REGIONAL REVIEW FINDING

ARC REVIEW CODE: R503011

<u>Submitting Local Government</u>: City of Alpharetta <u>Name of Proposal:</u> The Forum at Alpharetta Mixed-Use Development

<u>Review Type:</u> Development of Regional Impact

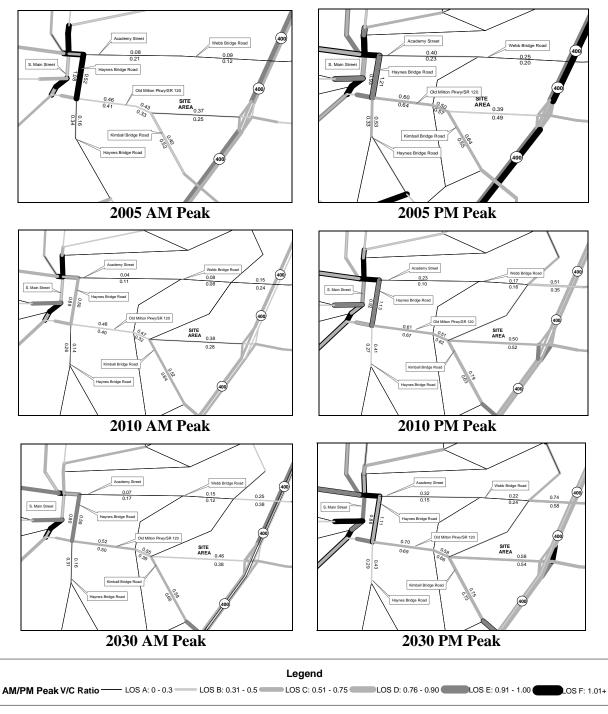
Incorporating the trip generation results, the transportation consultant distributed the traffic on the current roadway network. An assessment of the existing Level of Service (LOS) and projected LOS based on the trip distribution findings helps to determine the study network. The results of this exercise determined the study network, which has been approved by ARC and GRTA. If analysis of an intersection or roadway results in a substandard LOS "D", then the consultant recommends improvements.
